FACIA KIT Suits VE Series 1 models only

Tech bulletin. FP9350

USB Charging

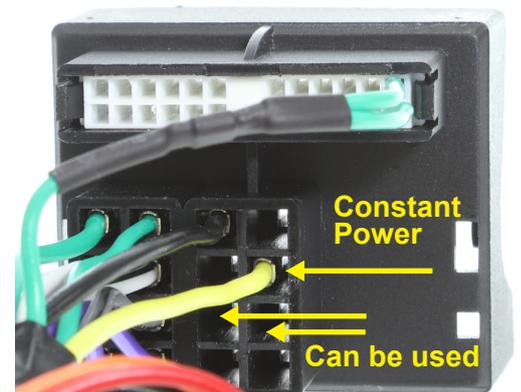
We have discovered that the USB port is not capable of fast charging apple devices. In fact the result is that it can effect the accessory output wire to the headunit and switch it off if the unit draws enough current. After speaking with many customers we have found that most people want a pass through cable. So the next batch will be supplied as a pass through cable to connect the rear USB to the front port.
